# UNITED STATES PATENT AND TRADEMARK OFFICE

# Office Action Summary

10/800,867

## **DETAILED ACTION**

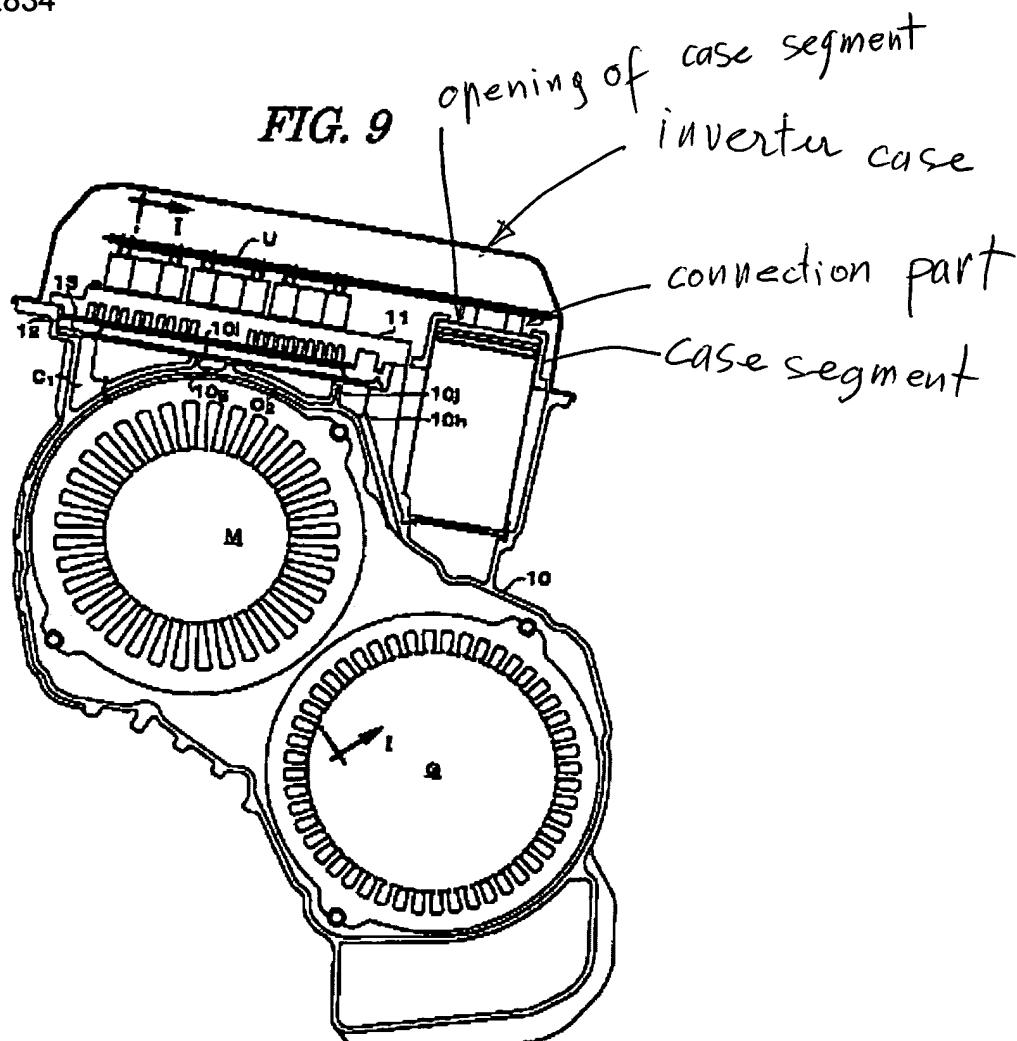
Regarding claims 15, 19 and 20, Hara et al. disclose a drive system wherein the electric power devices are connected to the respective inverters with connection parts (please see markups below) which extend out from the corresponding case segments.

Regarding claims 21 and 16, Hara et al. disclose a drive system wherein each of the connection parts has a terminal which extends through the corresponding case segment and which projects into the inverter case (Fig. 9).

Regarding claims 17 and 22, Hara et al. disclose a drive system wherein each of the terminals is positioned near an opening of the corresponding case segment.
